CITY AND COUNTY OF SAN FRANCISCO
Port of San Francisco

Contract No. 2852
Amador Street Infrastructure Improvements

ADDENDUM No. 03
Issued: August 19, 2024

ENLARGED PLAN "F"
SCALE: 1"=5'

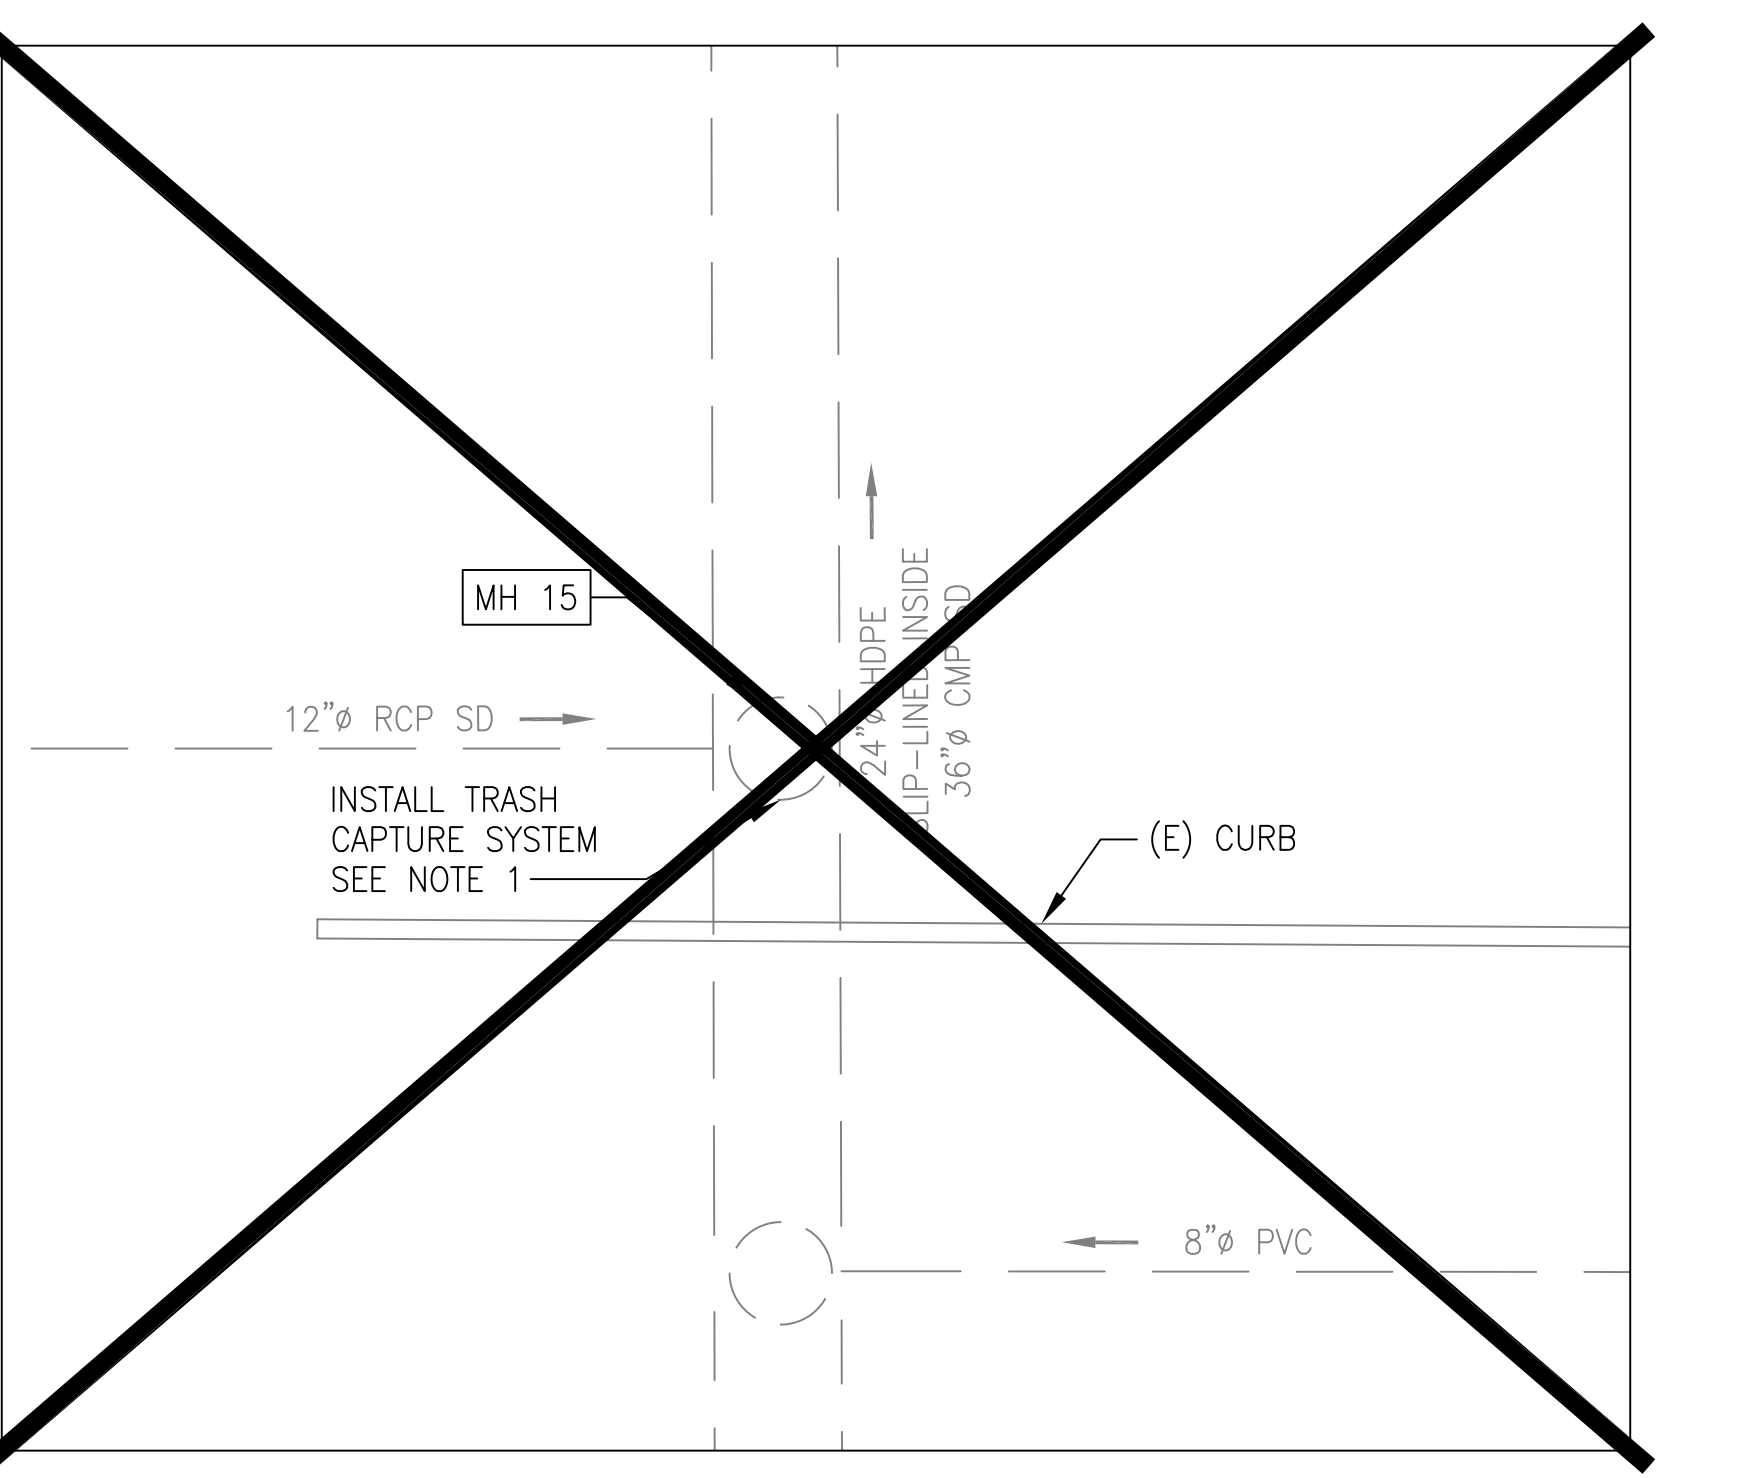
- 1) **Sheets C-3 & C-6** – Modifications to driveway designs and details.
- 2) **Sheets L-3** – Updated specification references related to imported topsoil.
- 3) **Sheets H-2, H-4, H-5, & H-10** – DELETED work related to installation of high flow trash
- 4) **Sheets E-3** – Updated antenna material to aluminum.
- 5) **Sheets E-5, EI-01, & EI-02** – Updated service pedestal mounting.

- FURNISH AND INSTALL HIGH FLOW DEVICE, CROSSLINKED HIGH DENSITY POLYETHYLENE "DOWNSTREAM DEFENDER" BY HYDRO INTERNATIONAL INSIDE (E) MH. SEE SPEC SECTION 33 33 00 FOR ADDITIONAL REQUIREMENTS.
- FURNISH AND INSTALL HIGH FLOW DEVICE "JDS72-3636 JENSEN DEFLECTIVE SEPARATOR" OR APPROVED EQUAL BY THE CITY REPRESENTATIVE. SEE SPEC SECTION 33 33 00 FOR ADDITIONAL REQUIREMENTS.
- EXISTING MH IS INSIDE CEMEX LEASEHOLD. CONTRACTOR SHALL COORDINATE WITH THE CITY REPRESENTATIVE FOR ACCESS TO PERFORM THE WORK. EXISTING MANHOLE HAS EXISTING GRATE COVER OVER SOLID MANHOLE COVER.
- TRASH CAPTURE DEVICES SHALL BE RATED FOR THE FOLLOWING FLOW RATES (MIN):
 A) PLAN "C": 5.2 (CFS)
 B) PLAN "D": 1.4 (CFS)
 C) PLAN "E": 12.1 (CFS)
 D) PLAN "F": 3.3 (CFS)

- M. High flow removable trash collection device with new concrete manhole "JDS72-3636 Jensen Deflective Separator", conforming to the requirements in the Contract Plans, or approved equivalent.
